**City of Woodinville
SR 202 Widening and Trestle Replacement Project
Project No. PW ST-13-002
Federal Aid No. HLP-0202(066)
TIB Project No. 8-1-198(006)-1**

**ADDENDUM No. 2
dated
July 28, 2026
to
Contract Documents and Plans**

PARTIAL WALL ELEVATION

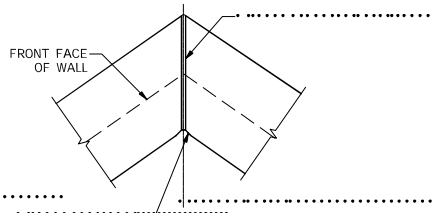
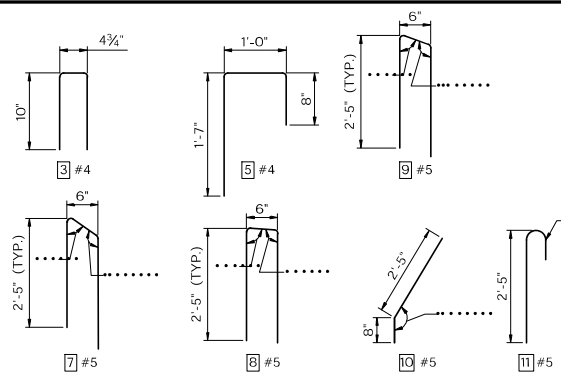
- 3.) **Plan Sheet 41, Drawing No. W07:** Size of rebar No. 1 was changed from a #5 to a #4 in the Partial Wall Elevation detail.

32	Sheet W07, we are unable to locate the spacing of any of the reinforcement, especially bar numbers 1 and 2 for the cast-in-place fascia. Please advise.	See "Partial Wall Elevation" on sheet W07 for spacings of reinforcement. Bar 1 is #4 @ 1'-0" max spacing (misabeled bar size on detail). Bar 2 is #5 @ 6" max spacing. See Attachment 12 for revised Drawing No. W07.
33	Sheet L23, the lean rail cap appears to be a 2x10, yet we are unable to locate any specific information regarding size and species of wood. Please advise.	Detail A/L23 shows the dimensions of the lead rail. For wood species, bidders shall use lpe wood as the basis of design material. See Attachment 16 for revised Drawing No. L4

NO.	REVISION	DATE	BY	CHK
1	ADDENDUM 2 - REVISED CALLOUT	7/23/26	DCR	AR

TYPICAL SHAFT DETAILS

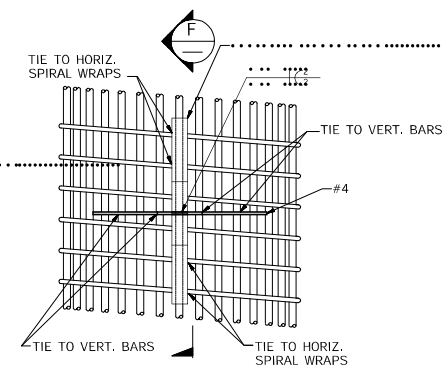
- 6.) **Plan Sheet 139, Drawing No. BR05:** The 90-degree outward bar bends for the shaft have been substituted with HRC 670 T-Heads (or approved equal).

NO.	REVISION	DATE	BY	OK
1	ADDENDUM 2 - MODIFY SHAFT REINFORCEMENT	7/24/26	DCH	RL
